NL-07-1155

Edwin I. Hatch Nuclear Plant
Proposed Modification of the
Unit 1 Core Shroud Stabilizer Assemblies

Core Shroud Stabilizer Modification Evaluation Summary

Figure 1

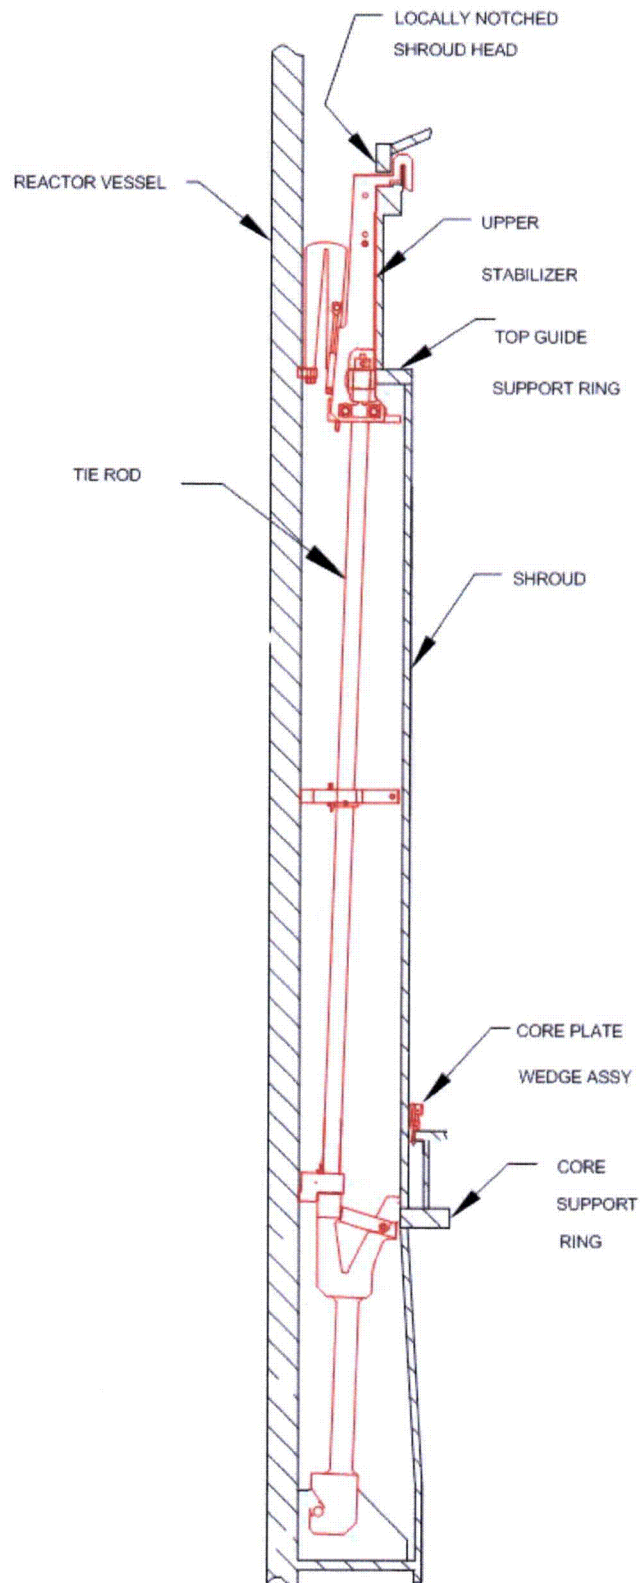
Hatch Unit 1 installed core shroud stabilizers in 1994 (1RFO15) on a pre-emptive basis in lieu of ultrasonic (UT) inspection of the core shroud horizontal welds. The stabilizers functionally replace the shroud horizontal welds H1 through H8. The stabilizer assembly is shown in Figure 1. The General Electric Company (GE) designed and installed the Hatch Unit 1 tie rod assemblies.

Figure 2

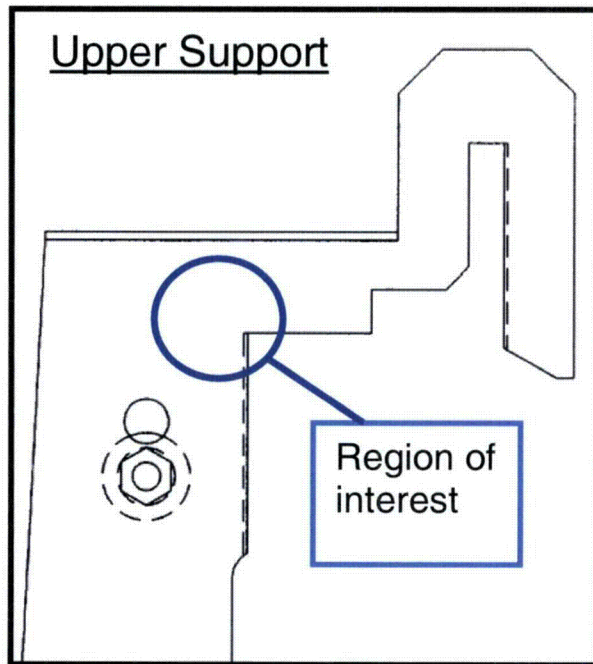
The potential for high peak stress in the shroud stabilizer upper bracket design is attributed to the lack of a specified radius at the corner junction between horizontal and vertical legs of the bracket (see Figure 2), which creates a high stress concentration. This high peak stress reduces the design life of the shroud stabilizer upper support.

The geometry of the replacement hardware (upper support, tie rod nut, and other associated upper support components) is shown in the attached GE design Documents. These newly-designed components incorporate features that improve their ability to resist IGSCC. These features include: (1) a large fillet radius at the corner of the upper support; (2) increased width and thickness of the upper support; (3) sharp edges eliminated; and (4) a larger root radius of the tie rod nut threads. The original tie rod installation required that cutouts be made in the shroud head flange to accommodate the upper supports, which hang over the shroud flange. The width of the cutouts will be increased to accommodate the increased width of the modified upper supports.
